Subject: Progress Energy Florida Levy Nuclear Plant Units 1 and 2

This letter provides additional information in response to comments raised in your letter to the DEP Siting Coordination Office, dated August 26, 2008.

Figure1. Temperature vs. Distance from Discharge Canal

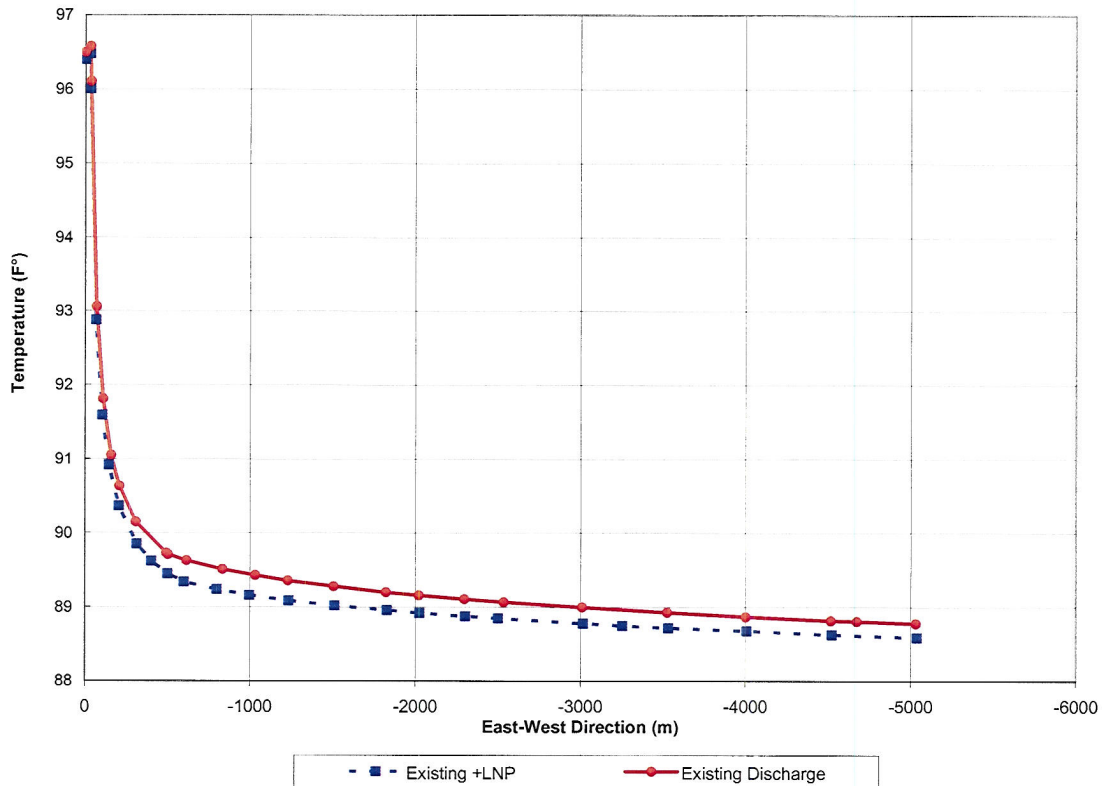
Section 5.3.2.1 identifies that discharge for the Levy nuclear plant will equal an additional 81 million gallons per day of heated water. As such, the Levy Nuclear Plant discharge represents a significant increase in cumulative heat energy that will require additional mitigation. Average temperature may or may not measurably decrease, but how will more heated effluent affect other physical properties capable of producing impact? What additional control technologies could yield beneficial mitigation of impact to regionally significant waters, fisheries and aquatic ecosystems? What other options exist outside of control technology to reduce the impact of increased heat discharge flow?

Please refer to the response to Comment 5 for background information on the LNP discharge and the expected combined flow characteristics at the CREC discharge canal. Combining the lower temperature LNP discharge with the CREC discharge is not expected to increase the overall temperature of the combined discharge plume with distance. In fact, the 4 percent increase in flow volume from LNP will result in more dilution of the thermal plume. The comparison between the existing and proposed combined discharge streams, as estimated with plume dilution modeling, indicates that the addition of the LNP discharge to the existing CREC discharge will have no significant or discernible effect on the thermal footprint of the CREC discharge, as illustrated in the following figure.
